## **ITEM**

<b>Application Reference</b>	<b>DC/091420</b>
<b>Location:</b>	Marple Library Memorial Park Marple Stockport SK6 6BA
<b>PROPOSAL:</b>	Demolition of existing Marple Library, Marple Clinic and Marple Police Station buildings and erection of leisure and community building (Use Class E, F1, and F2) with associated parking, landscaping, drainage, pedestrian and highways improvements and other supporting infrastructure.
<b>Type Of Application:</b>	Full Application
<b>Registration Date:</b>	14/03/2024
<b>Expiry Date:</b>	13/06/2024 (Extension of Time Agreed)
<b>Case Officer:</b>	Mark Burgess
<b>Applicant:</b>	Stockport Metropolitan Borough Council
<b>Agent:</b>	Stantec

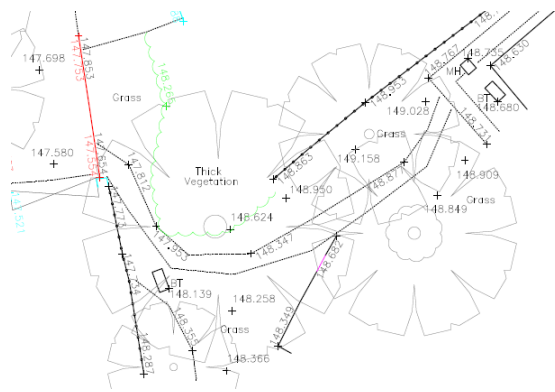
- 1) The layout of the police car park is very tight, with little manoeuvring area provided. It is unclear whether vehicles could be manoeuvred into / out of each parking space and, as such, I would request the submission of vehicle swept-path tracking diagrams to demonstrate that all parking spaces could be accessed.
- 2) The shared path in front of Hollins House is presently accessed from the site access road. The reconfigured car park will, however, result in two parking spaces blocking access to this when in use. Whilst the use of these spaces could be managed, access to for cycles will be restricted. As such, I would recommend that the existing path adjacent to the spaces is widened to allow this to be used by cyclists, as per the plan below.

- 3) The drawings do not accurately reflect the corner of the site adjacent to the southern end of Parkfield Avenue and do not show how the footpath through the car park will tie in to Parkfield Avenue. The site layout drawings need to be amended to reflect what is on the ground (as per the topo below) and clearly show how the footpath will tie into Parkfield Avenue (I would suggest it follows the line of the existing path).

- 4) There is a discrepancy between the SMBC and OOB drawings in respect to the shared use path to the east of Hollins House and around the new building.

Revised and additional drawings are therefore required to address these issues.

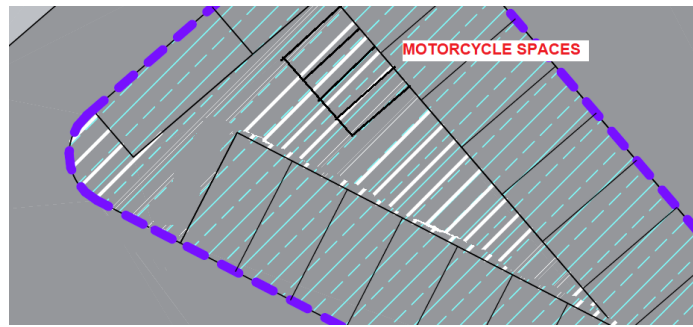
- 6) Whilst the proposal to widen the path between the car park and the path in front of Hollins House so it can be used by cyclists is noted and welcomed, shared use paths should be a minimum of 3m in width. As such, it should be widened from 2.4m to 3m in width, along the lines shown on the drawing below.

- 7) Although it is acknowledged that the site is fairly constrained and it would be beneficial to maximise the number of car parking spaces within the site, it is considered that dedicated motorcycle parking should be provided (as required by Policy T-1 and in line with the adopted standards) and I note that there are locations where it could be provided. One option would be to provide them in the centre of the car park, as shown on the drawing below. As shown, sufficient room is available for 4 no. 1.5m by 2.8m spaces to be provided. By moving the spaces in the central bank of spaces to the south slightly to the south-east, adequate space to access them can also be provided.

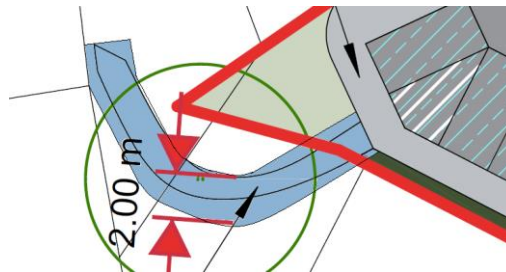
- 8) I note that the revised layout better reflects the existing pedestrian route between the site and Parkfield Avenue. This, however, is narrow and not properly surfaced. Noting that it will be a key route to the west (and will link with the new ramp into Hollins Lane car park) it is considered that this should be improved. It should therefore be shown to be widened to 2m and surfaced in bitmac, along the lines shown on the drawing below. The drawing should be based on the topographic survey for this location, however, as the oobe drawings do not accurately reflect what is on the ground (notably the drawing shows the tree in the path which is not the case).

#### **OBJECTION - Reason: INSUFFICIENT INFORMATION**

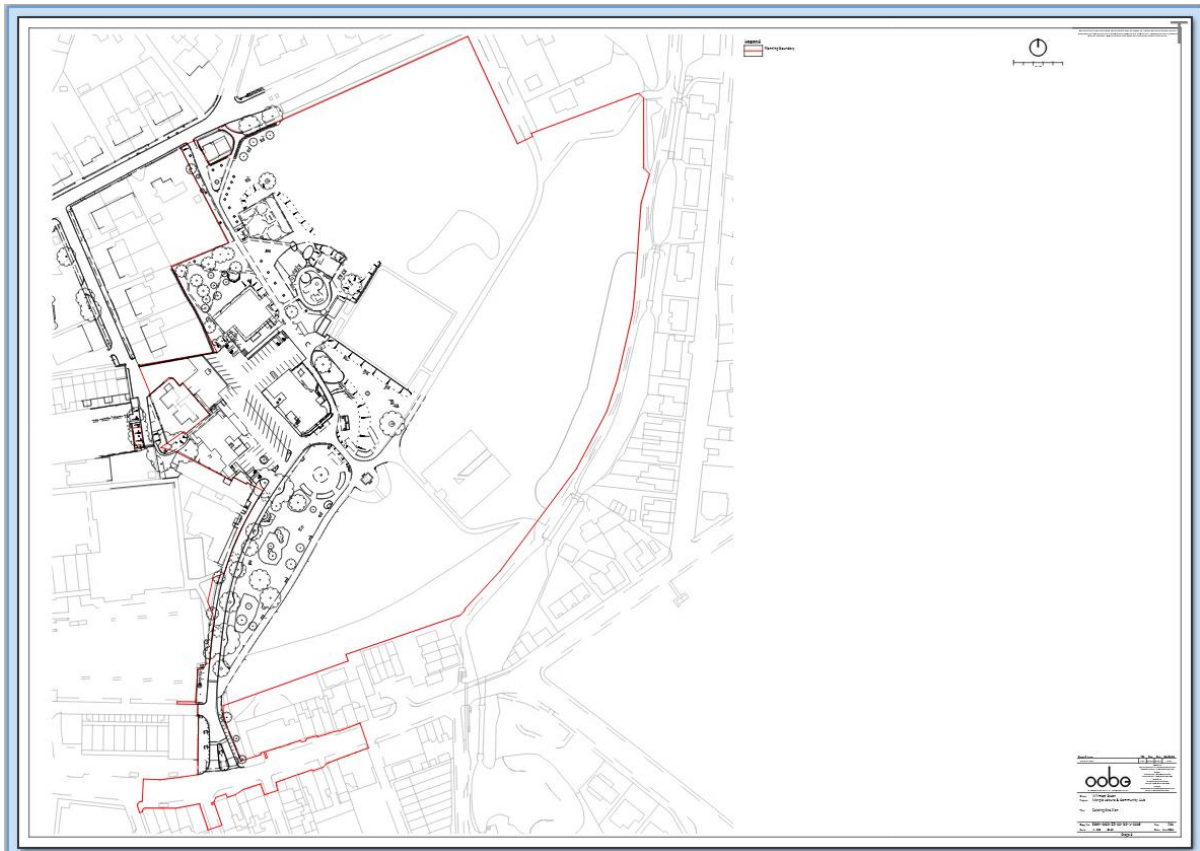
An additional 'Light Spillage Assessment' is required to be submitted in support of the application, in order for this service to adequately assess the impact of the external lighting scheme, upon the amenity and quality of life of residential receptors at 1 – 15 Parkfield Avenue.

*The 'Objection' would be reviewed, only, if the following information is provided, demonstrating that the proposal complies with material planning considerations.*

Willmott Dixon, Drawing Title: Proposed External Lighting Layout, 16.02.24, Drawing No. TAC-ZOXX-DR-E-9005, Rev P01.

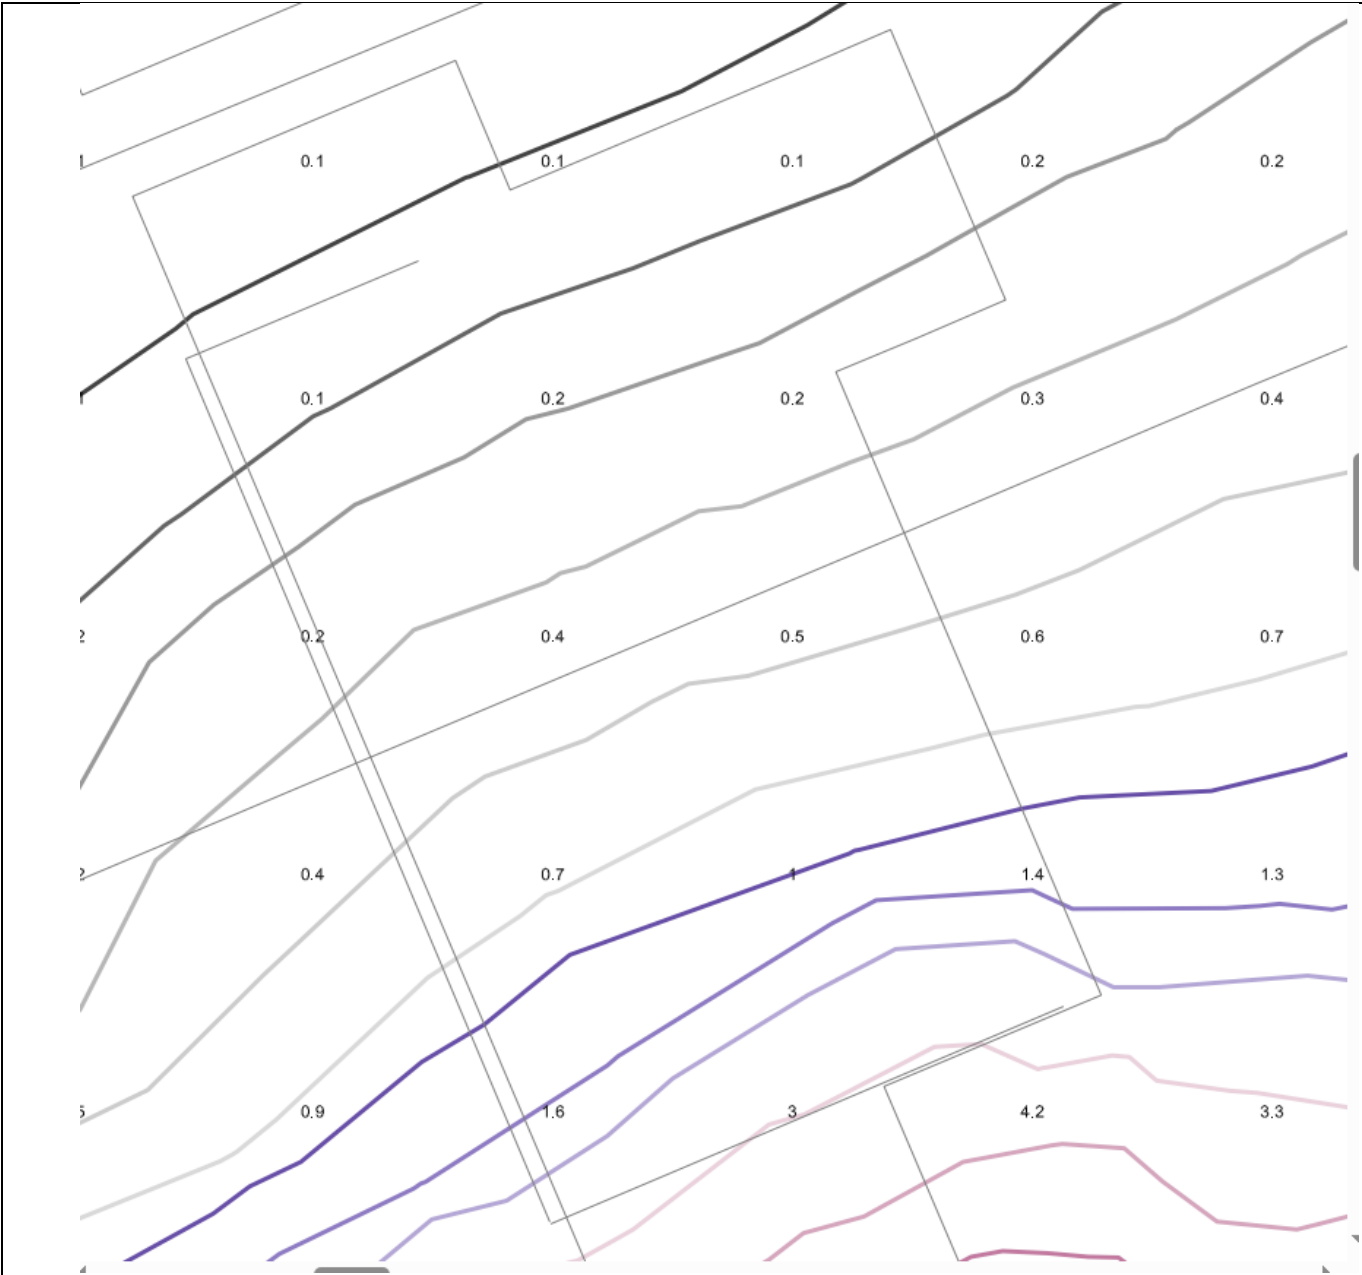
**RECEPTORS 9 & 11 Parkfield Avenue**

Assessment of the applicant's illumination assessment drawing; the lux levels at the residential windows of 9 & 11 Parkfield Avenue, appear to exceed the Institute of Lighting Professionals, *Guidance Note 01/21, The Reduction of Obtrusive Light*, and recommended Maximum Values of Light Parameters for the Control of Obtrusive Light – Light intrusion/ nuisance. The maximum value of vertical illuminance on premises, E3 Suburban, Pre-curfew 10 and post-curfew 2 on the south-east elevation of no. 11 Parkfield Avenue.

**RECEPTORS 13 & 15 Parkfield Avenue**

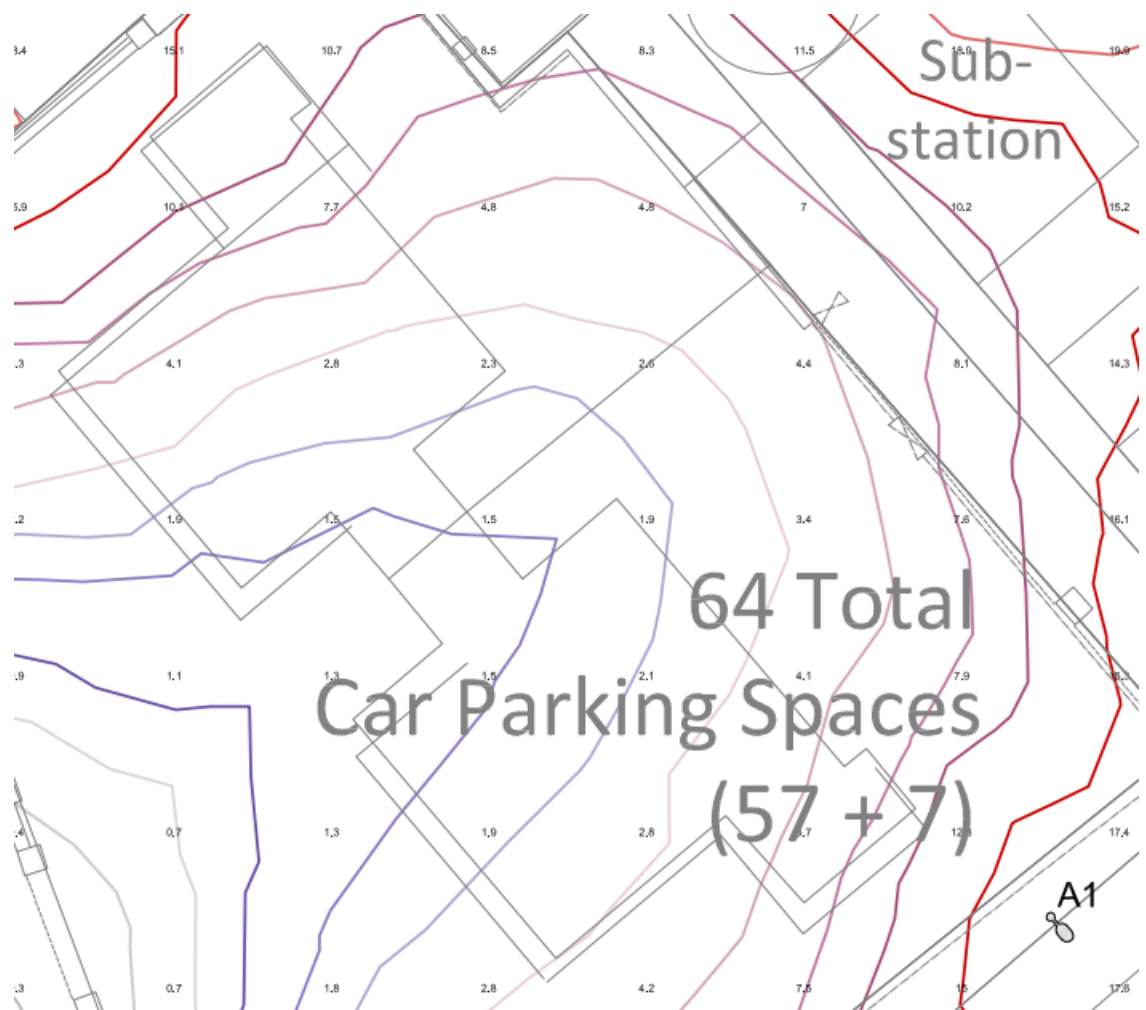
Assessment of the applicant's illumination assessment drawing; the lux levels at the residential windows of 13 & 15 Parkfield Avenue, appear to exceed the Institute of Lighting Professionals, *Guidance Note 01/21, The Reduction of Obtrusive Light*, and recommended Maximum Values of Light Parameters for the Control of Obtrusive Light – Light intrusion/ nuisance. The maximum value of vertical illuminance on premises, E3 Suburban, Pre-curfew 10 and post-curfew 2.

Figure 7: Potential ASHP compound locations.

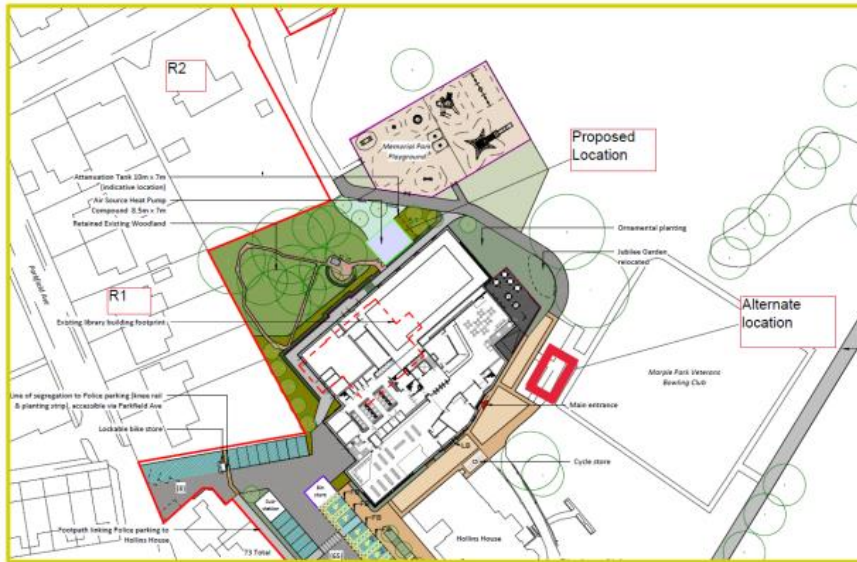
The project now includes an Air Source Heat Pump, an updated NIA has also been submitted: PACEConsult, Marple Community Hub – RIBA Stage 3 – Combined Acoustic Report, 16th May 2024 BIM Reference - MCH-PCE-XX-XX-T-J-00004 Pace Reference - PC-23-0160-RP4

Initial assessment has been completed based on the currently proposed location for the ASHP compound.

The residential houses on Parkfield Avenue and Station Road are the closest noise sensitive receptors to the proposed development. Identified as R1 and R2 in Figure 7 above.
